S4.55 LIST OF AMENDMENTS:

PROJECT  
THREE STOREY RESIDENTIAL FLAT BUILDING WITH BASEMENT CAR PARK AT:  
5 COMMONWEALTH PDE, MANLY, NSW  
CLIENT  
C.G. & I.B. KOUTSOS

DRAWING TITLE	STATUS	NUMBER	REVISION
GROUND FLOOR PLAN	S4.55	A1.01	s4.55
SCALE	STATUS	NUMBER	REVISION
1:100 @A3	S4.55	A1.01	s4.55

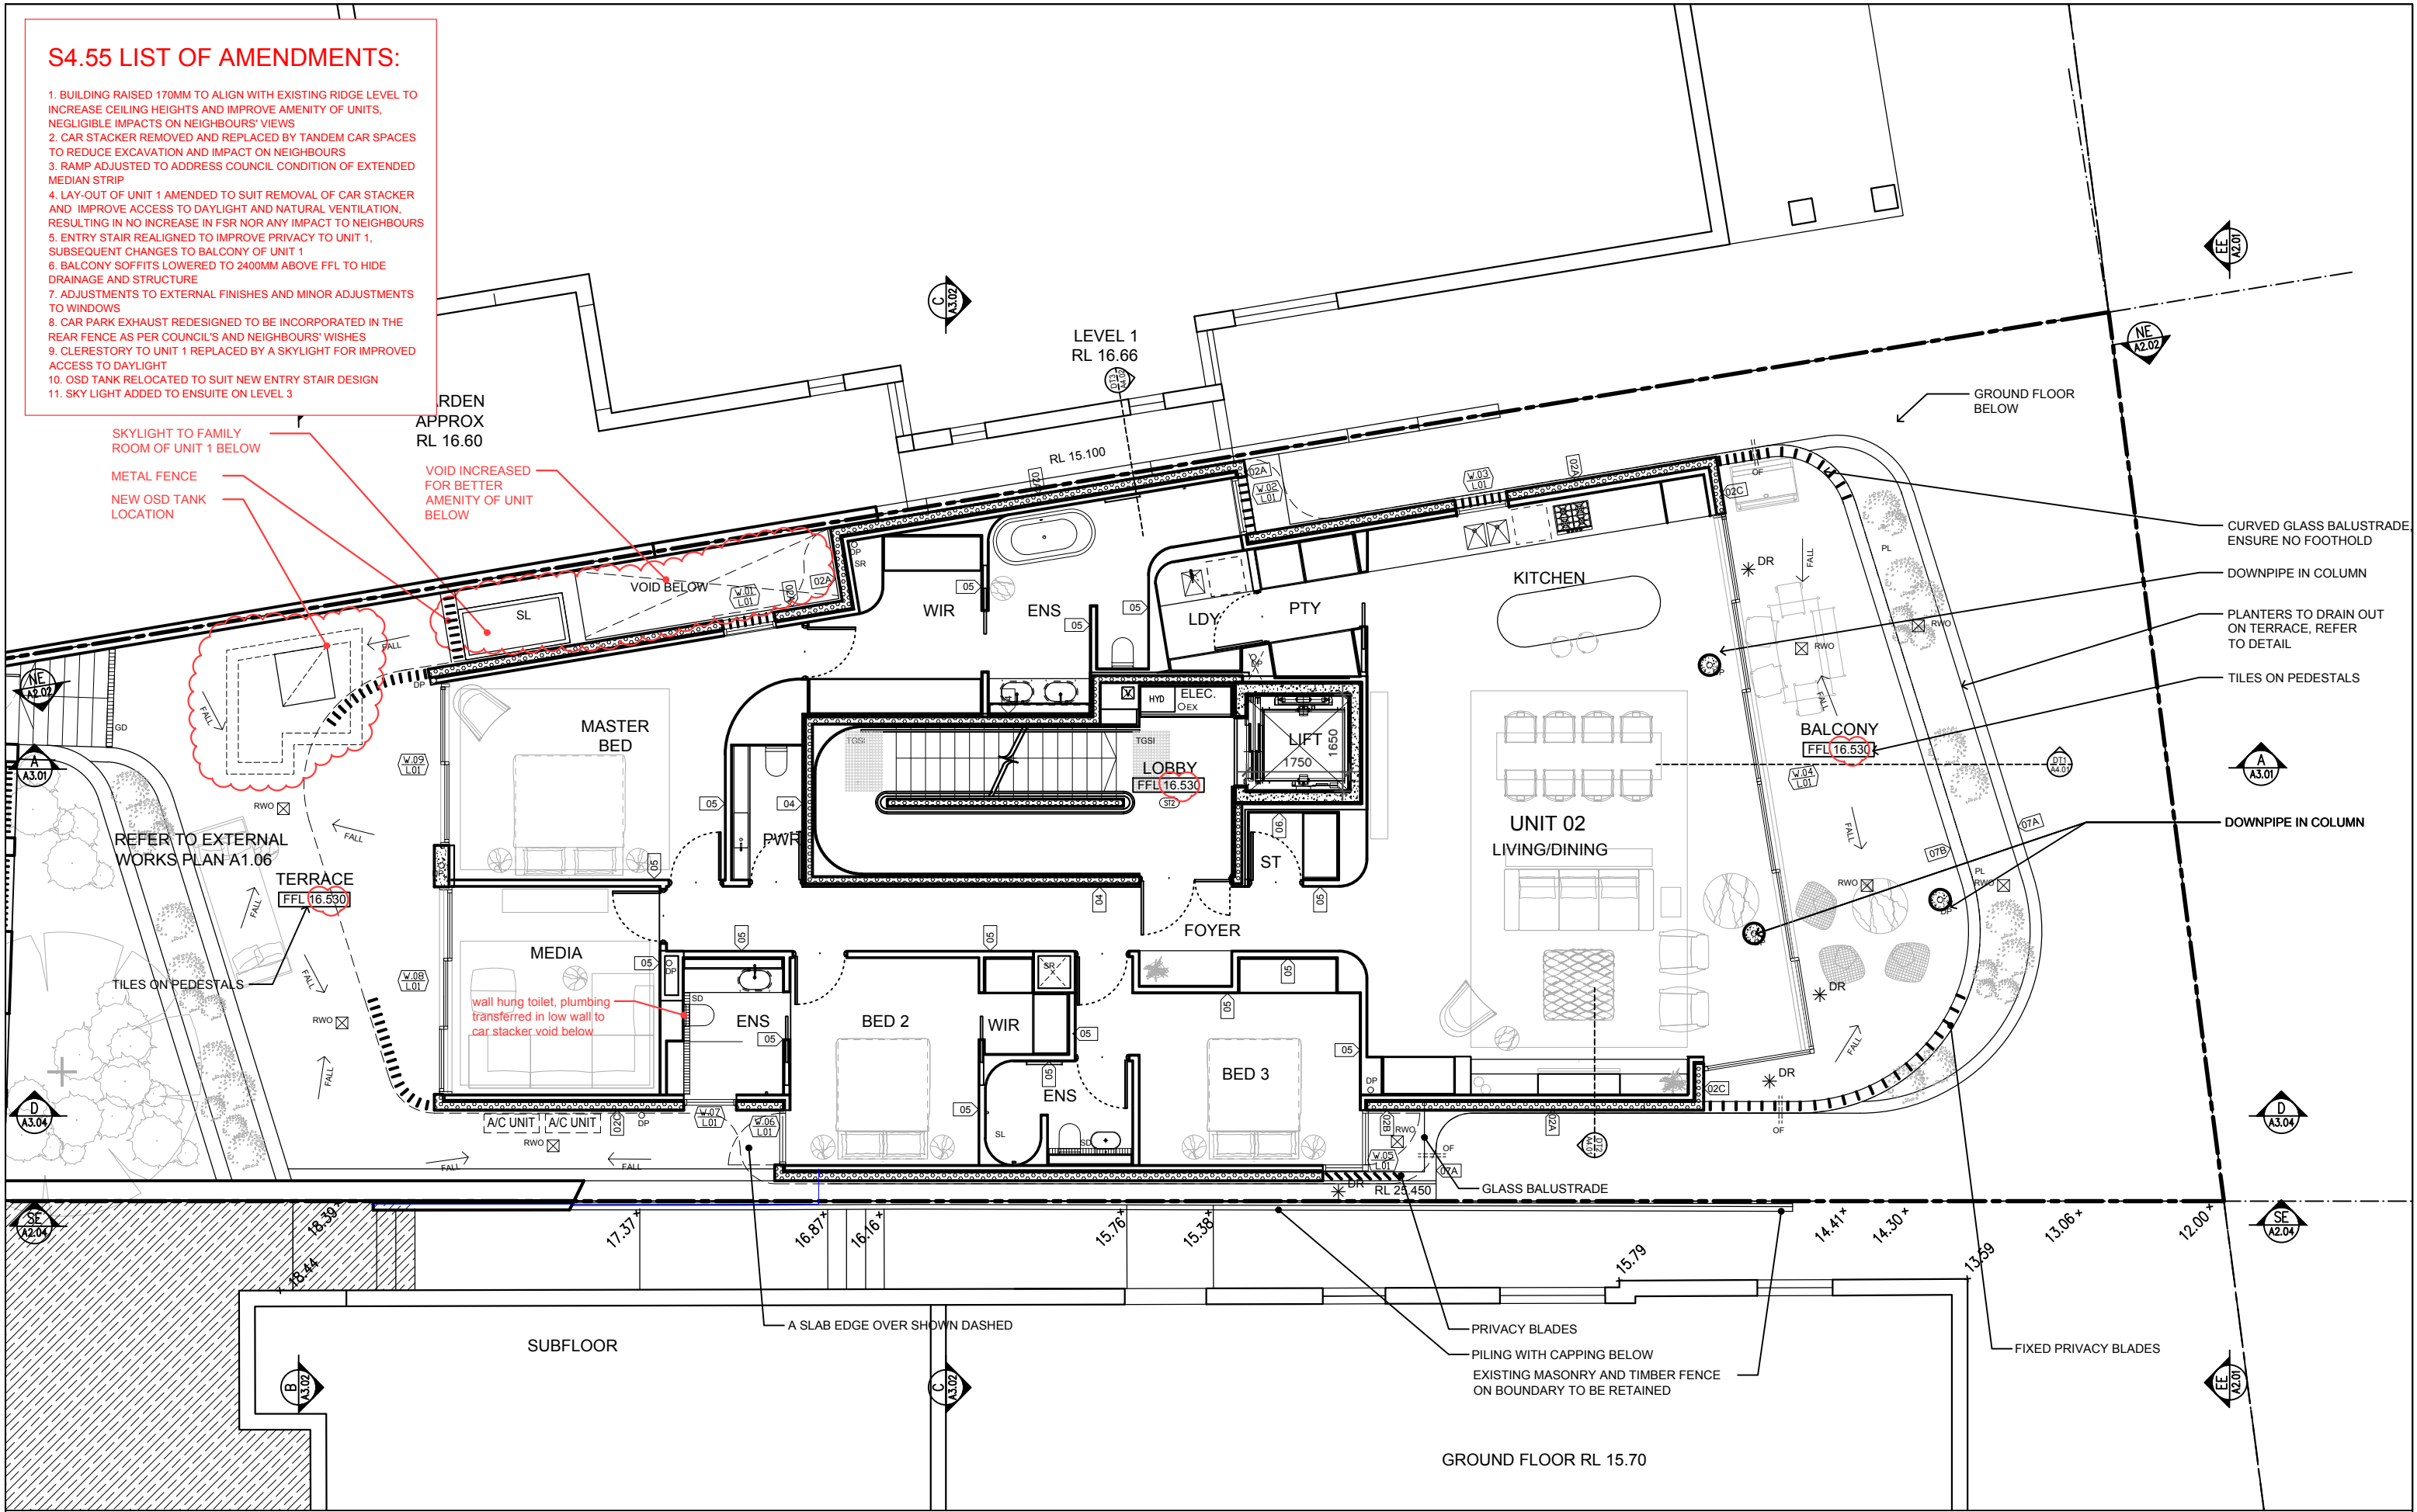
1. BUILDING RAISED 170MM TO ALIGN WITH EXISTING RIDGE LEVEL TO INCREASE CEILING HEIGHTS AND IMPROVE AMENITY OF UNITS, NEGLIGIBLE IMPACTS ON NEIGHBOURS' VIEWS

2. CAR STACKER REMOVED AND REPLACED BY TANDEM CAR SPACES TO REDUCE EXCAVATION AND IMPACT ON NEIGHBOURS
3. RAMP ADJUSTED TO ADDRESS COUNCIL CONDITION OF EXTENDED MEDIAN STRIP

4. LAY-OUT OF UNIT 1 AMENDED TO SUIT REMOVAL OF CAR STACKER AND IMPROVE ACCESS TO DAYLIGHT AND NATURAL VENTILATION, RESULTING IN NO INCREASE IN FSR NOR ANY IMPACT TO NEIGHBOURS

5. ENTRY STAIR REALIGNED TO IMPROVE PRIVACY TO UNIT 1, SUBSEQUENT CHANGES TO BALCONY OF UNIT 1
6. BALCONY SOFFITS LOWERED TO 2400MM ABOVE FFL TO HIDE DRAINAGE AND STRUCTURE

7. ADJUSTMENTS TO EXTERNAL FINISHES AND MINOR ADJUSTMENTS TO WINDOWS
8. CAR PARK EXHAUST REDESIGNED TO BE INCORPORATED IN THE REAR FENCE AS PER COUNCIL'S AND NEIGHBOURS' WISHES

9. CLERESTORY TO UNIT 1 REPLACED BY A SKYLIGHT FOR IMPROVED ACCESS TO DAYLIGHT
10. OSD TANK RELOCATED TO SUIT NEW ENTRY STAIR DESIGN
11. SKY LIGHT ADDED TO ENSUITE ON LEVEL 3

DRAWING TITLE  
**LEVEL 1 PLAN**

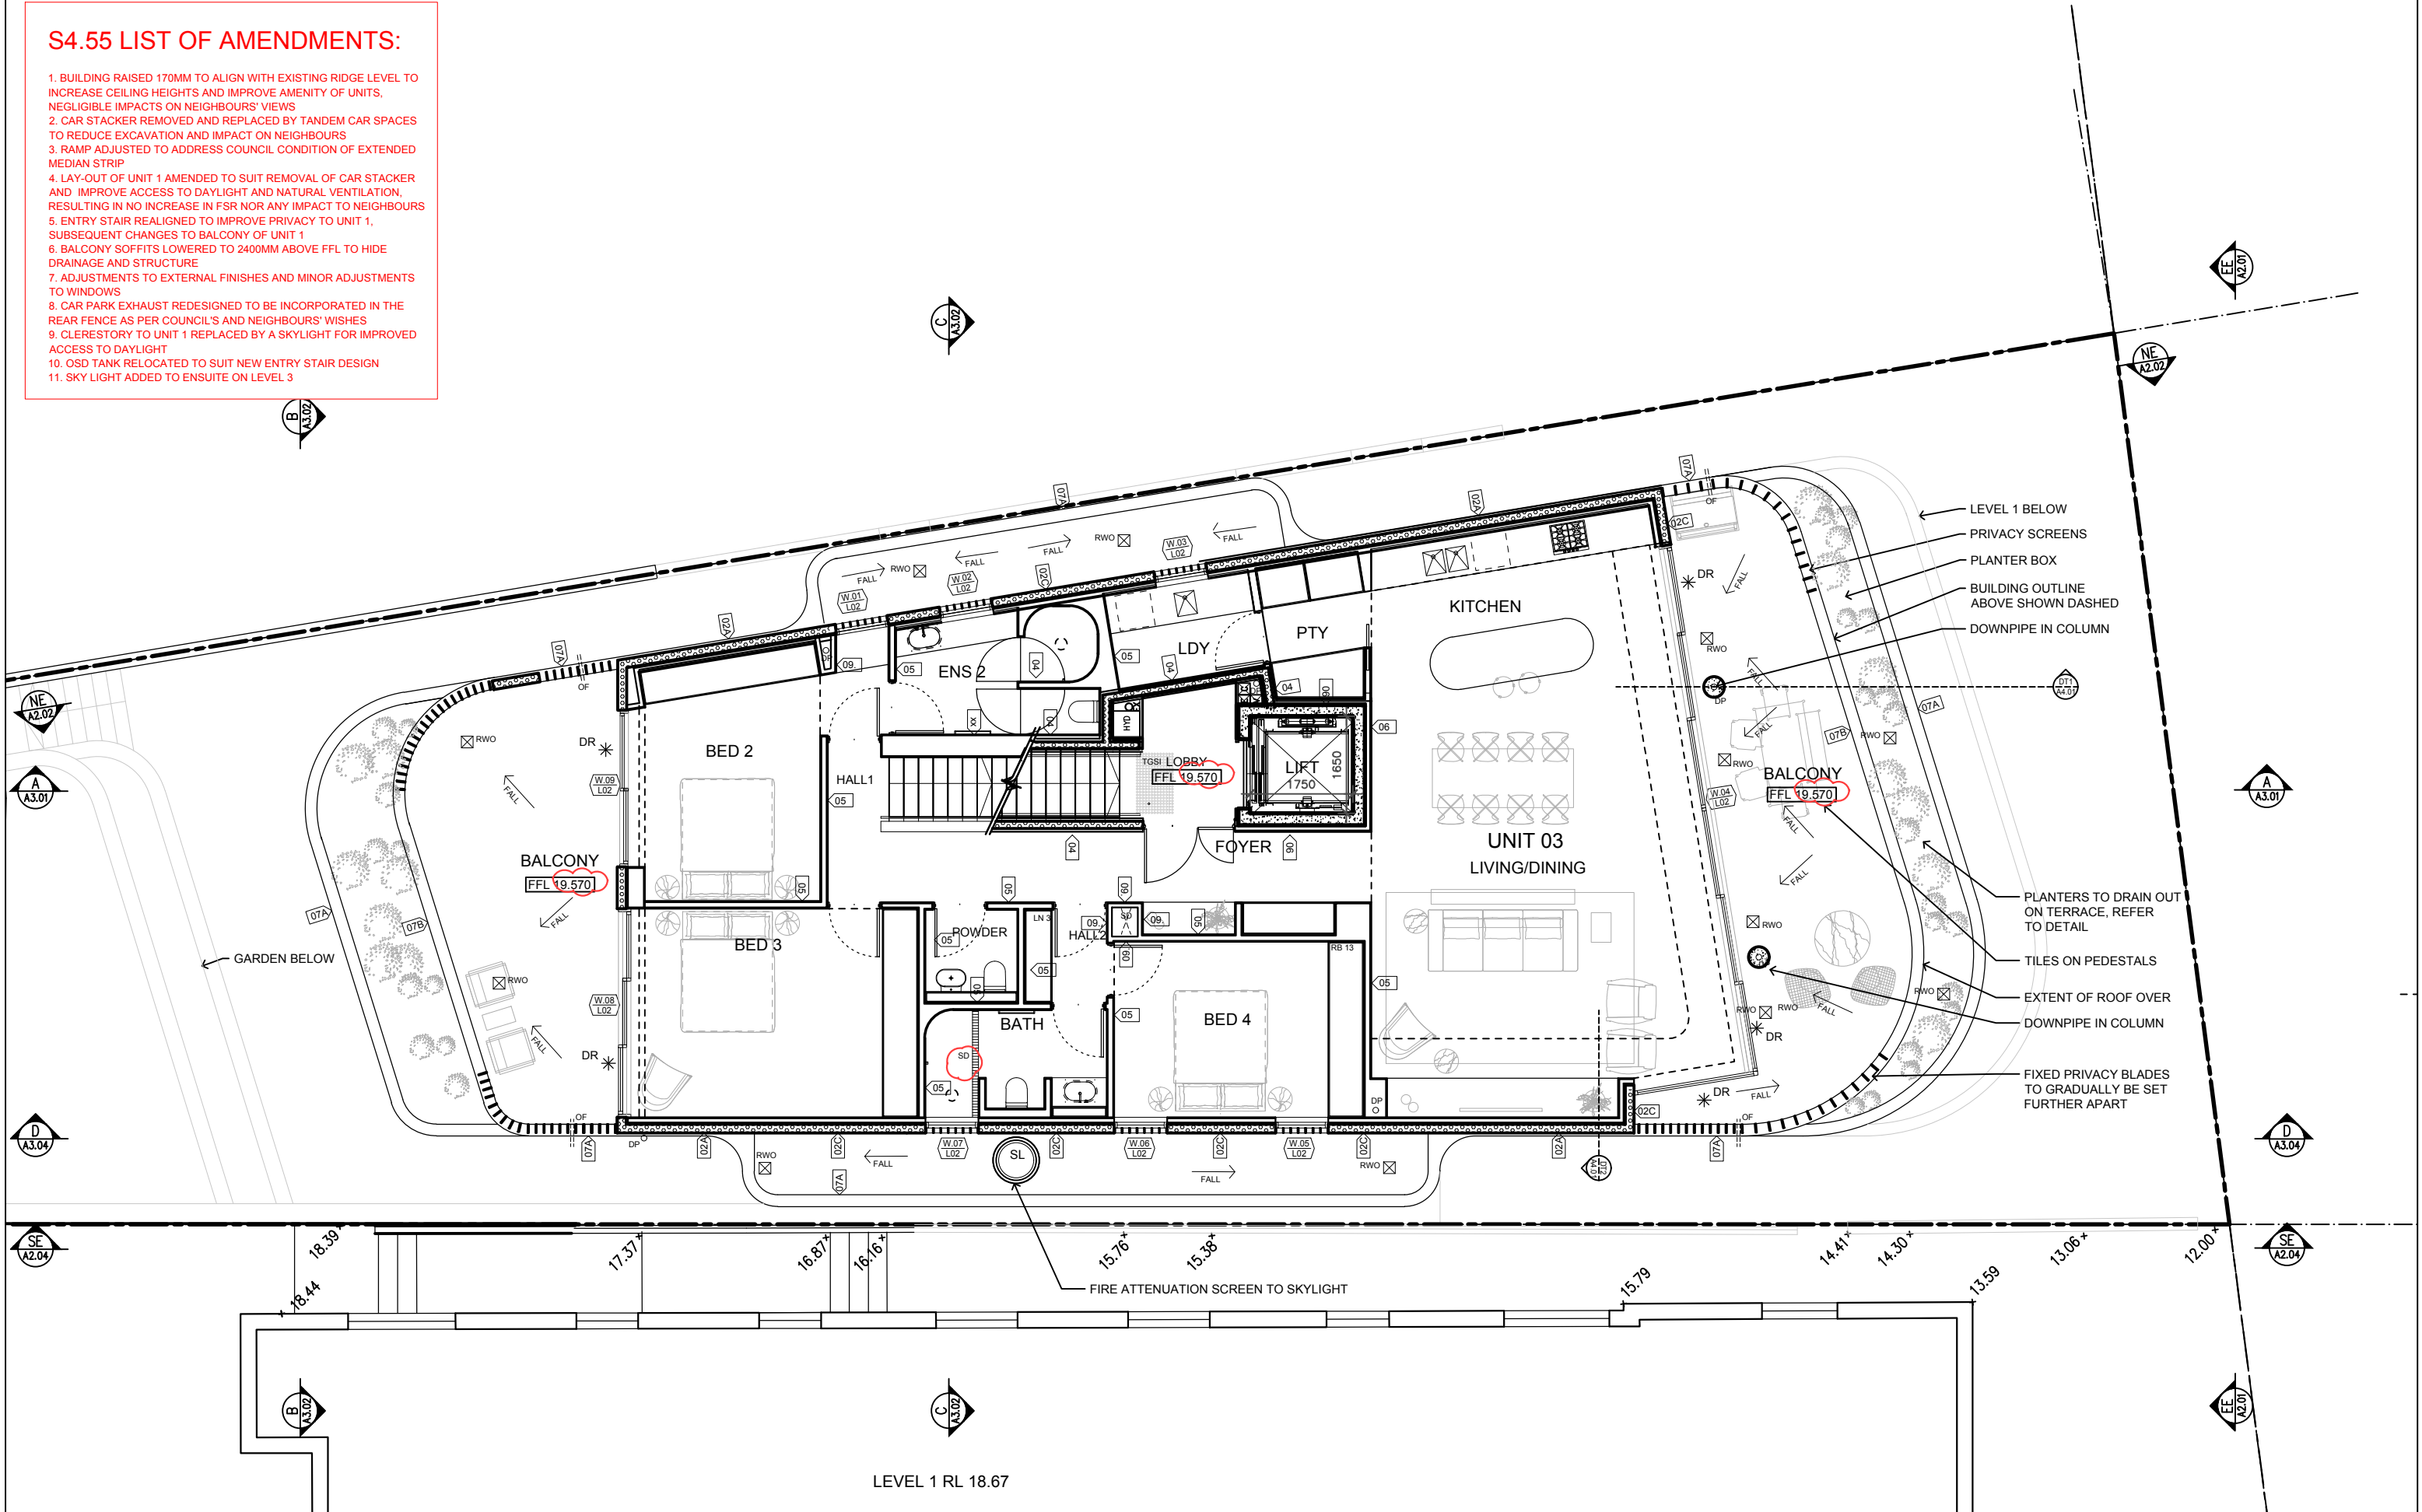
1. BUILDING RAISED 170MM TO ALIGN WITH EXISTING RIDGE LEVEL TO INCREASE CEILING HEIGHTS AND IMPROVE AMENITY OF UNITS, NEGLIGIBLE IMPACTS ON NEIGHBOURS' VIEWS

2. CAR STACKER REMOVED AND REPLACED BY TANDEM CAR SPACES TO REDUCE EXCAVATION AND IMPACT ON NEIGHBOURS
3. RAMP ADJUSTED TO ADDRESS COUNCIL CONDITION OF EXTENDED MEDIAN STRIP

4. LAY-OUT OF UNIT 1 AMENDED TO SUIT REMOVAL OF CAR STACKER AND IMPROVE ACCESS TO DAYLIGHT AND NATURAL VENTILATION, RESULTING IN NO INCREASE IN FSR NOR ANY IMPACT TO NEIGHBOURS

5. ENTRY STAIR REALIGNED TO IMPROVE PRIVACY TO UNIT 1, SUBSEQUENT CHANGES TO BALCONY OF UNIT 1
6. BALCONY SOFFITS LOWERED TO 2400MM ABOVE FFL TO HIDE DRAINAGE AND STRUCTURE

7. ADJUSTMENTS TO EXTERNAL FINISHES AND MINOR ADJUSTMENTS TO WINDOWS
8. CAR PARK EXHAUST REDESIGNED TO BE INCORPORATED IN THE REAR FENCE AS PER COUNCIL'S AND NEIGHBOURS' WISHES

9. CLERESTORY TO UNIT 1 REPLACED BY A SKYLIGHT FOR IMPROVED ACCESS TO DAYLIGHT
10. OSD TANK RELOCATED TO SUIT NEW ENTRY STAIR DESIGN
11. SKY LIGHT ADDED TO ENSUITE ON LEVEL 3
